DIST	COUNTY	ROUTE	KILOMETER POST TOTAL PROJECT	SHEET No	TOTAL SHEETS
04	SF,Ala	80	12.2/14.3 0.0/4.0	407a 09S91	1204

CONTRACT CHANGE ORDER NO._____
SHEET _____ OF _____

DETAILS
TRAFFIC OPERATIONS SYSTEM
TOS FIBER OPTICS RISER DIAGRAM
SKYWAY STRUCTURES-WB

E-978

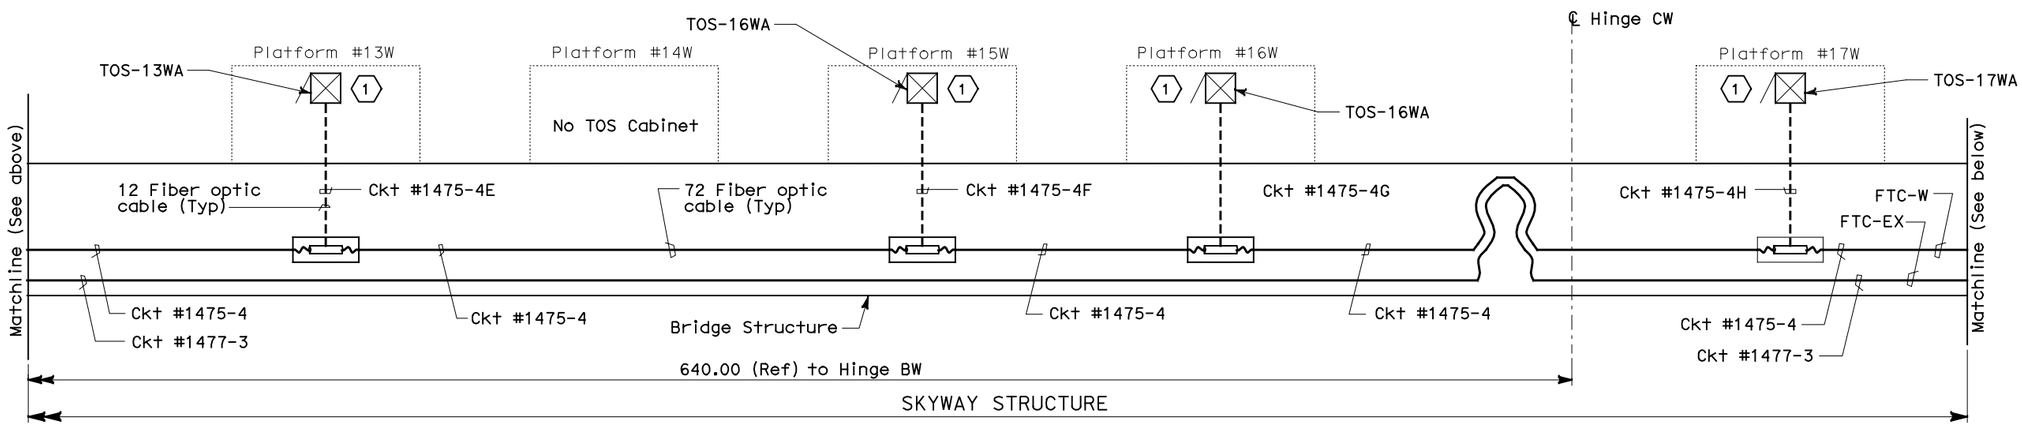
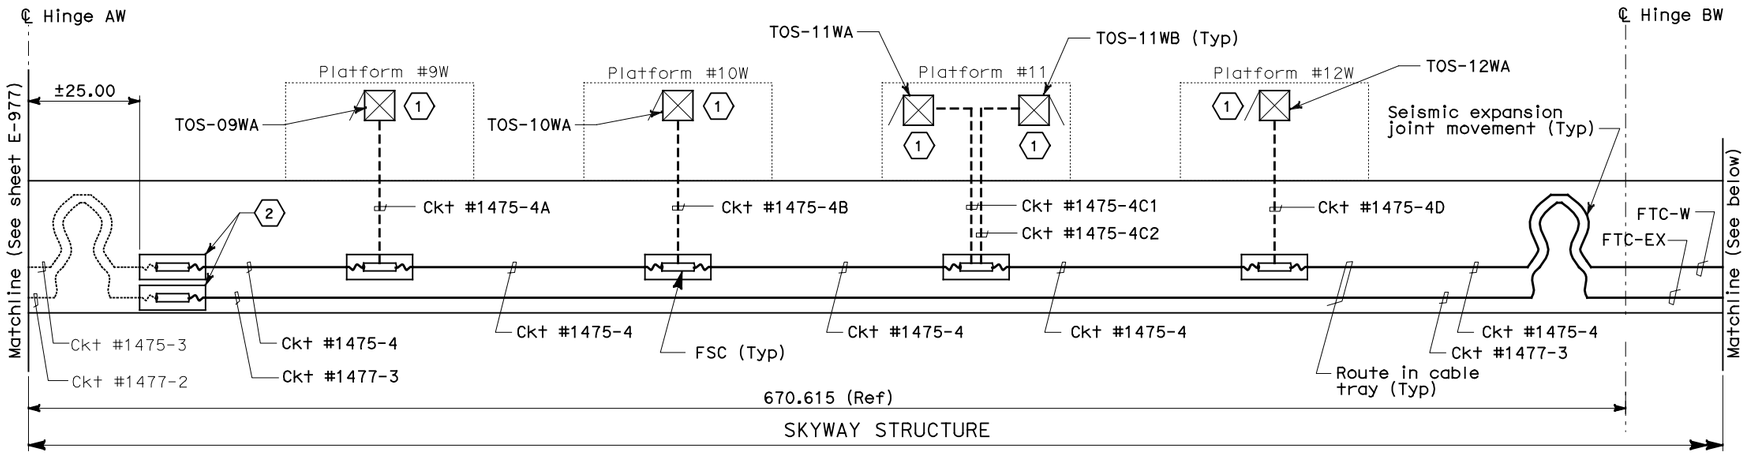
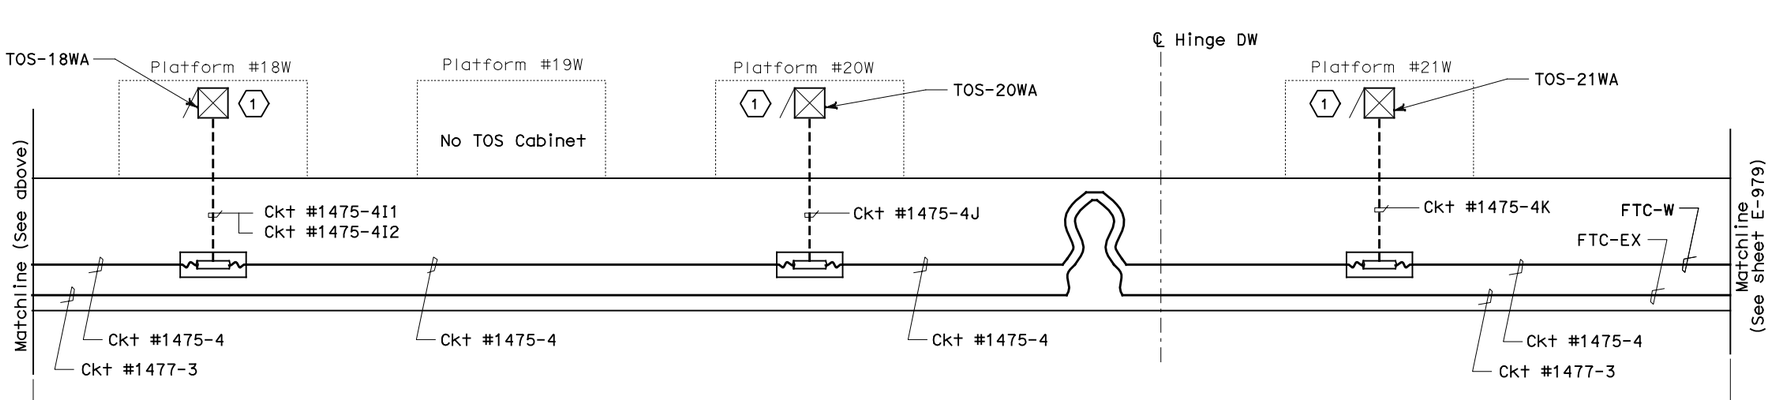
(1) Contractor shall terminate FPC in TOS cabinet.

(2) The fiber optic splice at this location is based from the existing contract interface. However, the design intent of the fiber optic cable shall be continuous in the entire cable/circuit length. If cable needs to be spliced, use FSC and place FSC in splice cable tray.
